Product Change Notification - SYST-24WWIL685

ERRATA - dsPIC33EPXXX(GP/MC/MU)806/810/814 and PIC24EPXXX(GP/GU)810/814 Errata

1) Updated code example in silicon issue 23 (Flash Memory).

dsPIC33EPXXX(GP/MC/MU)806/810/814 and PIC24EPXXX(GP/GU)810/814 Family Silicon Errata and Data Sheet Clarification

FIGURE 1: SIMPLIFIED BEHAVIOR

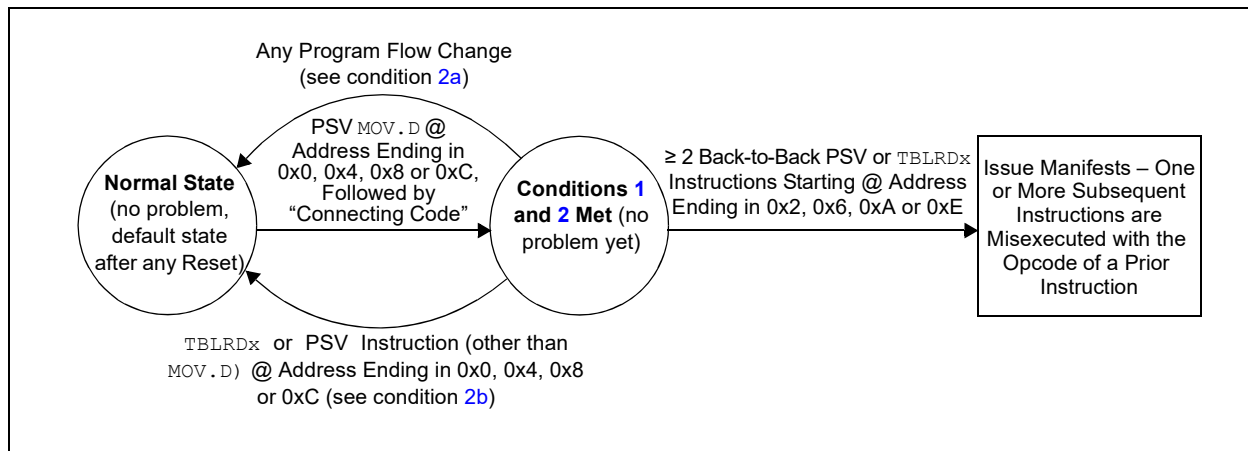
Note: This issue is deterministic based on the instruction sequence executed, and is not sensitive to manufacturing process, temperature, voltage or other application operating conditions that do not affect the instruction sequence.

3.	≥ 2 back-to-back PSV or <code>TBLRDx</code> instructions are executed (following the code of condition 2), where the first of the back-to-back instructions is located at an address ending in 0x2, 0x6, 0xA or 0xE.

Figure 1 provides an example of the effective behavior.

1. All instances of PSV `MOV.D` can be replaced with two PSV `MOV` instructions instead. Non-PSV `MOV.D` instructions acting on RAM/SFRs do not need to be modified; or
2. If not already present, a program flow change instruction (such as `BRA $+2`) can be inserted above back-to-back data Flash read sequences; or
3. Back-to-back data Flash read instruction sequences can be broken up by inserting a non-Flash read instruction (such as a `NOB`) in between the Flash read instructions; or
4. The alignment of the code can be shifted to avoid the required opcode location addresses.

C code built with MPLAB® XC16 Compiler, Version 1.32, or later, implements the work around by default. However, if the application uses Assembly language routines, these should be manually modified to implement the work around. Additionally, if precompiled libraries are used, these should be built with XC16 Version 1.32 or later. For additional information, please visit: www.microchip.com/erratum_psrds_psrds.

FIGURE 16-2: HIGH-SPEED PWM MODULE REGISTER INTERCONNECTION DIAGRAM

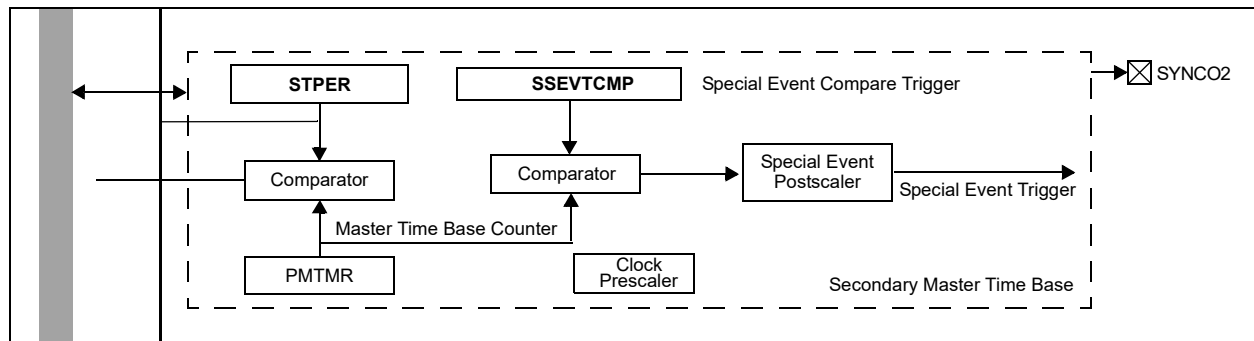
In **Figure 16-2: High-Speed PWM Module Register Interconnection Diagram**, the Secondary Master Time Base section has been updated. The updated text is shown in **bold** in [Figure 16-2](#) below.
